STAFF REPORT ACTION REQUIRED

Alteration to a Designated Heritage Property (revised application) – 129 St. Clair Avenue West (Deer Park United Church)

Date:	February 16, 2012
То:	Toronto Preservation Board Toronto and East York Community Council
From:	Acting Director, Policy & Research, City Planning Division
Wards:	Ward 22 St. Paul's
Reference Number:	P:\2012\Cluster B\PLN\HPS\CC\March 5/6 2012\ccHPS15

Fig 61. Longitudinal section of courtyard scheme (ERA).

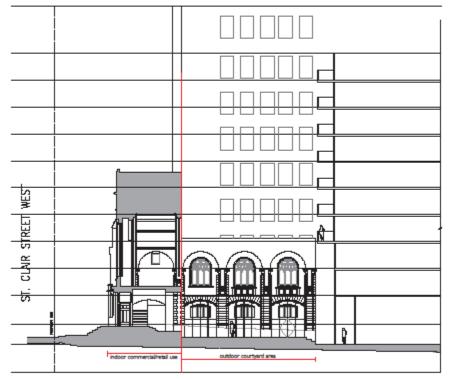
5. Weather-proofing of interior materials which will be exposed by the new courtyard will be required, the details of which will be included in a future conservation plan. The tower and front portion of the church will be enclosed to create indoor commercial/retail space. This semi-public programming invites a broader public to enjoy the heritage resources of the site.
